Support Bulletin-SB-24-10015

Title: 208-06-5022Y2 Updates

Product Line: FAS

Model: Harnessing

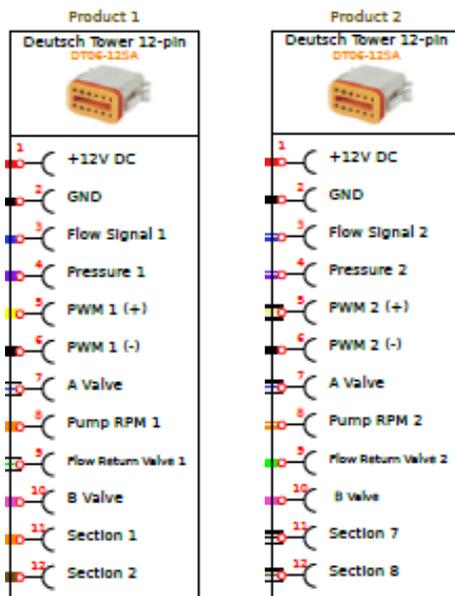
**Overview:** A/B valve control for Gen3 LiquiShift is now built into the Product 1 and Product 2 connectors of the 208-06-5022Y2 harness. This harness can now be used for Gen3 LS while using CAN zip valves. It still has the section connectors 1-6, 7-12, and 13-18 for standard section valves for a 2nd product. Another combination could be NH3 with standard section valves on product 1 and Gen3 LS with CAN zip valves on product 2. All kits, quotes, and orders have been updated to the Y2 version of this harness.
